Sign Variance - 1484 Dundas St W

Date:	December 16, 2008
To:	Toronto and East York Community Council
From:	Director, Toronto Building, Toronto and East York District
Wards:	Ward 18 – Davenport
Reference Number:	2008TE049

This report reviews and makes recommendations on a request by Daniel Bordonali of Sutherland & Associates on behalf of M + MJ Limited for approval of variances from Chapter 297, Signs, of the former City of Toronto Municipal Code to permit, for third party advertising purposes, a non-illuminated fascia sign on the east elevation of the building at 1484 Dundas Street West.

Attachment 1: Proposed Signage

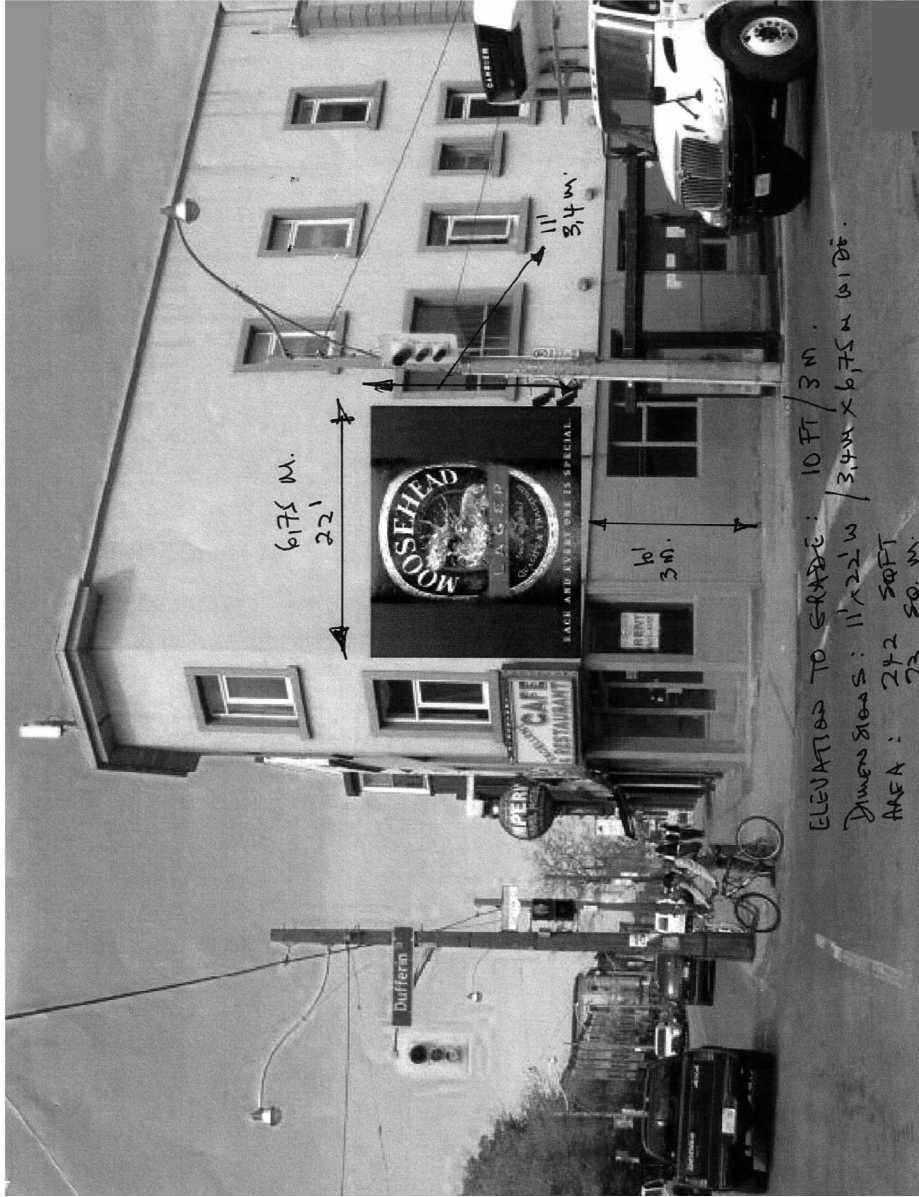
Sign By-law Section and Requirements	Applicant's Proposal	Required Variance
2. Chapter 297-10D(5)(f)	To install a non-illuminated fascia sign, for third party advertising purposes, on the east elevation of the building facing Dufferin Street.	A fascia sign, for third party advertising purposes, is not permitted to face a street.

The first variance is required because the proposed sign would be located on the east elevation of the building and it would face Dufferin Street. The Municipal Code does not permit third party signs to face a street. The intent of the by-law is to protect the business tenants in the building to display their first party signage without forcing them to compete with the advertising industry for their third party signage. In this instance the proposed sign would be substantially larger than and directly beside the existing first party fascia sign use to identify the ground floor tenant.

Given the size and positioning of the proposed sign in relationship to the existing signage and building, staff recommends refusal of this application. The variances are major and not within the general intent and purpose of the Municipal Code.

1. Toronto and East York Community Council refuse the request for variances to permit, for third party advertising purposes, a non-illuminated fascia sign on the east elevation of the building at 1484 Dundas Street West.
